Access Compliance Report

Public Rights-of-Way

(Curb Ramps)

Intersection ID: 44190	Main Street: ROZZELLES_LANDING_DR	Cross Street: CODDINGTON_RIDGE_DR	Location: NE
ADA ID: 4F98504F6D90	Ramp Type: BlendTrans1	Initial Pass/Fail: Fail	Overall Compliance: No
Severity Score: 8.75			
Codes/Mitigation Info/Possible Solution		Field Measurements/Component Compliance

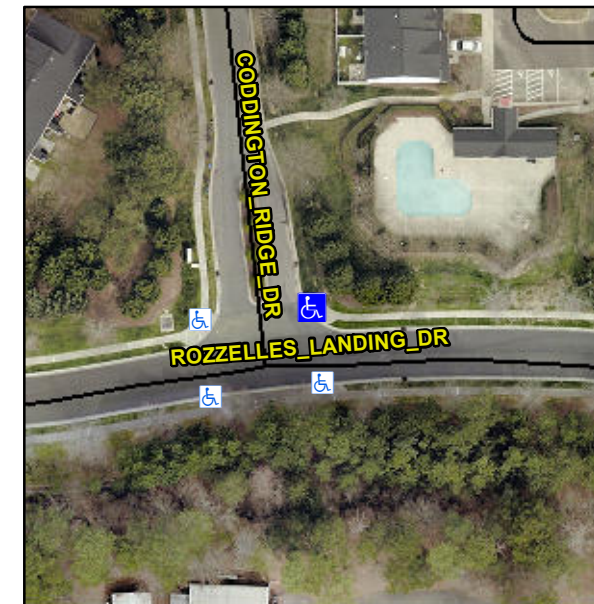
Compliance	Description	Data	Compliance	Description	Data
N/A	Ramp Length (in)	48.0	Yes	BlendTrans Slope (%)	4.5
No	Ramp Width (in)	36.0	Yes	BlendTrans XSlope (%)	1.2
N/A	Flare Type LT	N/A	N/A	Flare Type RT	N/A
N/A	Flare Slope LT (%)	N/A	N/A	Flare Slope RT (%)	N/A
N/A	Flare Traversable LT?	N/A	N/A	Flare Traversable RT?	N/A
N/A	Landing Length (in)	N/A	N/A	DWS Provided?	N/A
N/A	Landing Width (in)	N/A	N/A	DWS Contrast?	N/A
N/A	Landing Slope (%)	N/A	N/A	DWS Length (in)	N/A
N/A	Landing X Slope (%)	N/A	N/A	DWS Full Width?	N/A
N/A	Landing Curb? (Y/N)	N/A	N/A	DWS Offset (in)	N/A
N/A	Shared Landing?	N/A			
N/A	Gutter Ponding?	N/A	N/A	Gutter Slope (%)	N/A
N/A	Gutter Lip Ht (in)	N/A	N/A	Gutter X Slope (%)	N/A
N/A	Painted X Walk1?	No	N/A	Painted X Walk2?	No
	X Walk 1 Direction	To W		X Walk 2 Direction	To S
	X Walk 1 Width (in)	N/A		X Walk 2 Width (in)	N/A
	X Walk 1 Slope (%)	0.5		X Walk 2 Slope (%)	3.1
	X Walk 1 X Slope (%)	2.9		X Walk 2 X Slope (%)	0.6

Remove & Replace Curb Ramp With Two New Directional Ramps or Equivalent.

R304.5.1
